MONA OFFSHORE WIND PROJECT

Scoping Opinion

Document Reference: J8
APFP Regulations: 5(2)(a)
October 2023
Rev02

Adopted by the Planning Inspectorate (on behalf of the Secretary of State) pursuant to Regulation 10 of The Infrastructure Planning (Environmental Impact Assessment) Regulations 2017

Figure 11.2.3 Position and geographical area of herring closures within the North Sea as defined by Council Regulation (EC) No 850/98, amended by EC 2723/1999.

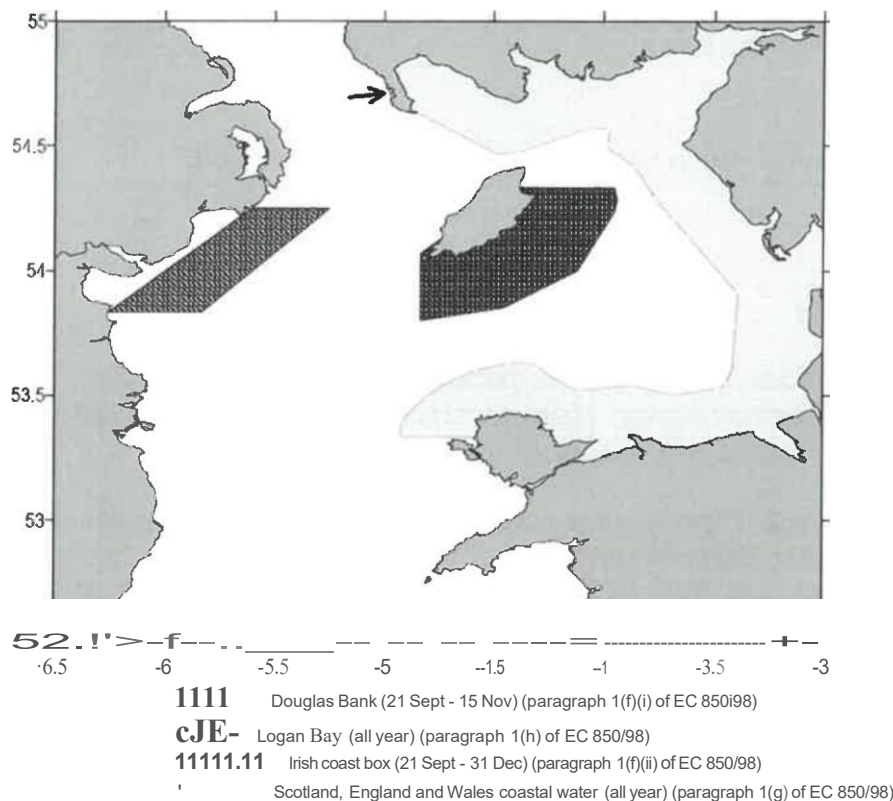
- Also please note the statutory herring spawning closure in Manx waters in relation to sections **4.2.4.19 - 21**. This was originally included within EU Council Regulations (EC) No 850/98 (amended by EC 2723/1999, and has since been rescinded. However, the closure remains in place within Manx law : <https://www.gov.im/media/1364592/sea-fisheriestechnicalmeasuresbye-laws20007.pdf> (byelaw 18).
